CITY OF WEST DES MOINES
CITY COUNCIL MEETING COMMUNICATION

ITEM: Woodland Hills of West Des Moines Plat 4, South side of Cascade Avenue, 840 feet west of the intersection of Cascade Avenue and S. 91st Street – Subdivide the property into 9 postage stamp lots and one outlot, and approval of a Site Plan to allow the construction of a detached townhome development and associated site improvements – Kimberly Development Corporation, LLC – PP-003131-2016/SP-003132-2016

RESOLUTION: Approval of Preliminary Plat and Site Plan

CITY OF WEST DES MOINES
PLAN AND ZONING COMMISSION COMMUNICATION

WOODLAND HILLS OF WEST DES MOINES
PLAT 4
LANDSCAPE PLAN

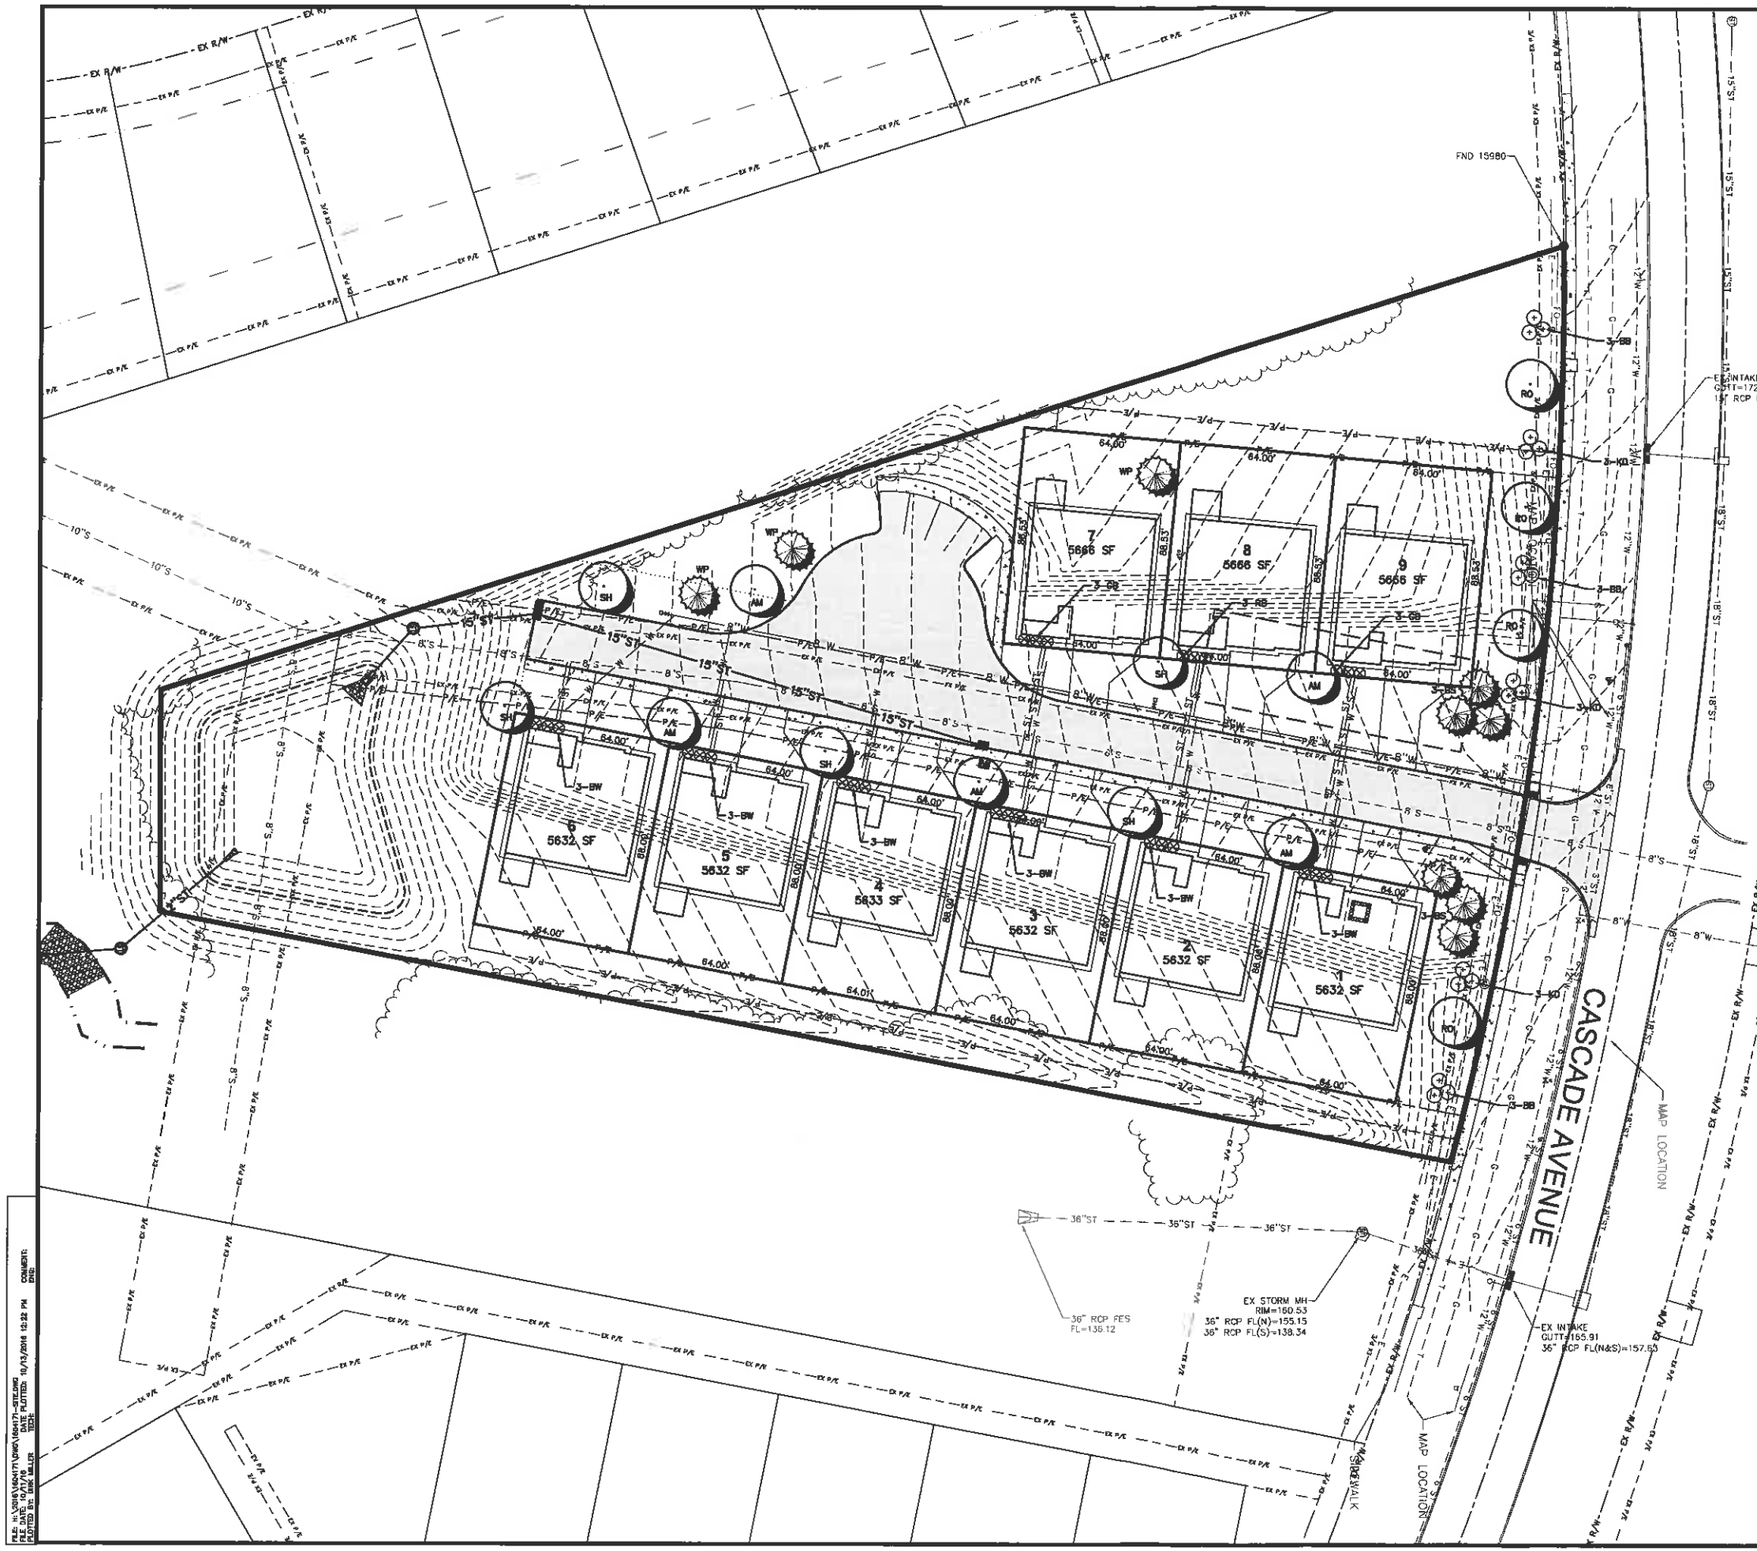
Plan and Zoning Discussion:
Mr. Daniel Miller, 832 S. Balsam Street, raised concerns with trees and grading that is proposed for the east side of the greenbelt located between Mr. Miller's property and the proposed townhome development. Mr. Miller is concerned that the removal of trees will open up views between the two developments. It was explained that the tree removal and grading encroachment into the greenbelt will be kept to a minimum. The developer's engineer, Josh Trygstad indicated that he would work with Mr. Miller to address his concerns. Since the meeting, the applicant has worked with Mr. Miller and they have come to the consensus to move two trees so that they screen the parking area.

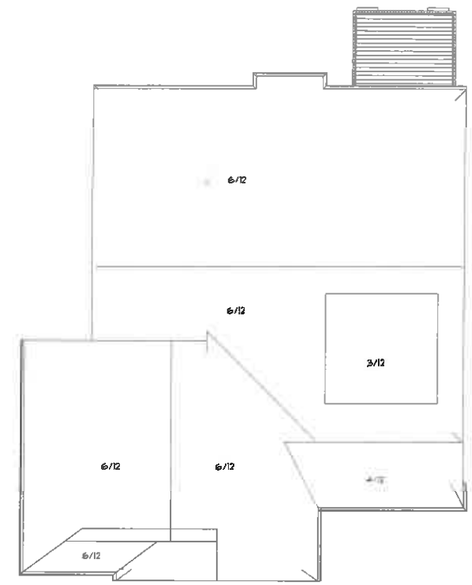
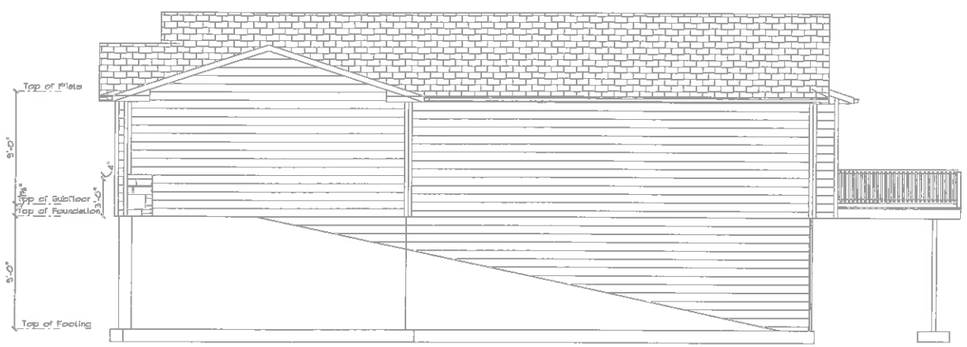
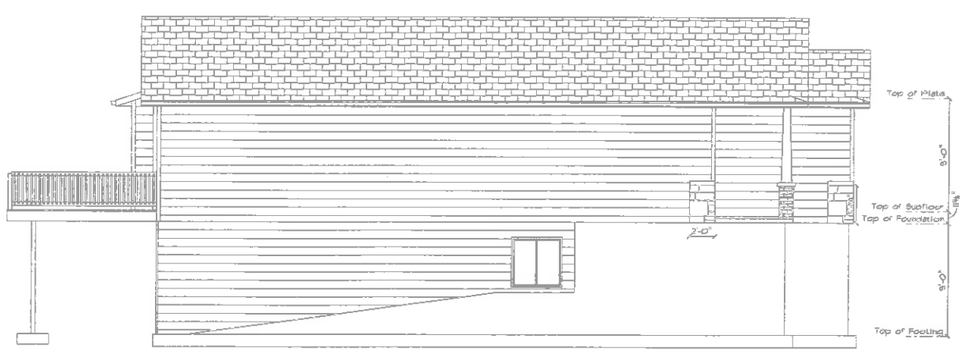
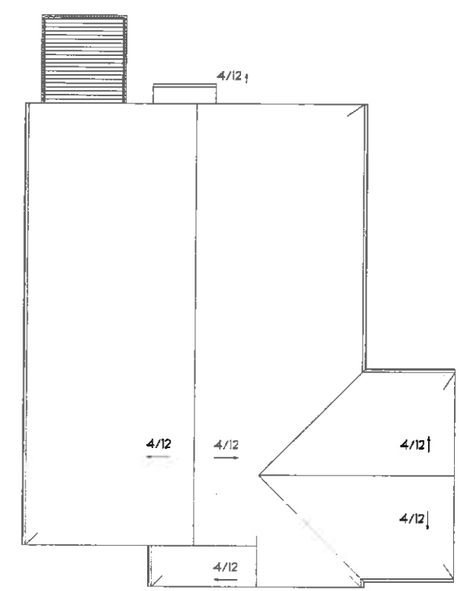
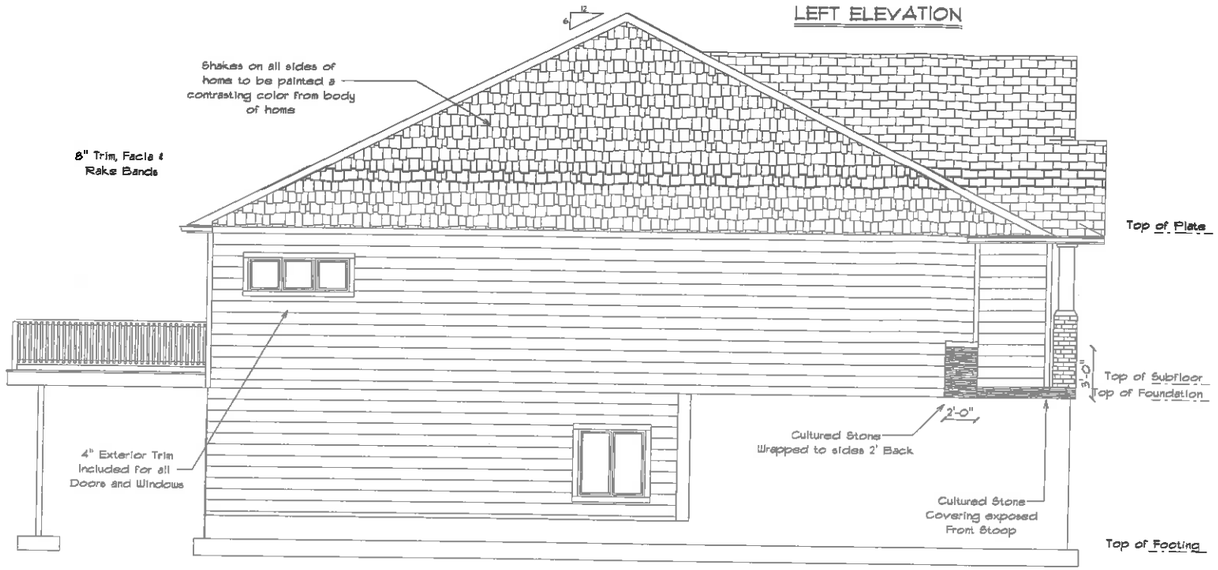
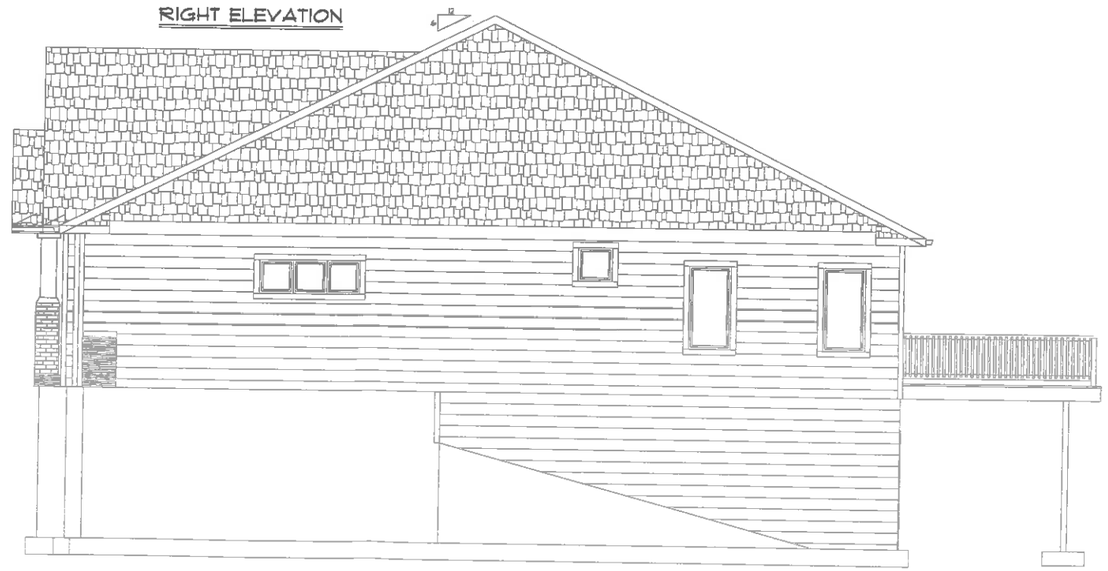
1. The applicant acknowledging that there shall be consistency in architectural style and compatibility in materials and colors between all homes. At the time of Building Permit submittal, should a home design be determined by staff to be is inconsistent to the approved images provided with this site plan, staff approval of a Level 1 Minor Modification Permit Application will be necessary prior to the issuance of a building permit, including footing and foundation permit; and

- *Architecture:* Traditional Medium Density townhome developments have typically utilized one building design on all lots with minor changes in colors and materials to provide variation. With this development, the applicant intends to construct custom units tailored to individual buyers. Because the development is detached townhomes on individual lots, which for all practical purposes will be perceived as and feel like traditional detached single family, staff is comfortable with not all buildings being identical. Staff has indicated to the applicant that for visual continuity, there must be consistency in the architectural style implemented and compatibility in the materials and colors between the buildings. The submitted exterior elevations are considered precedent images that set agreed upon architectural minimums. The design for each building will be reviewed for compatibility with the images when submitted for building permits. If a house plan is determined to be out of character with the approved images, it will require approval as a Level 1 Minor Modification prior to issuance of the building permit.
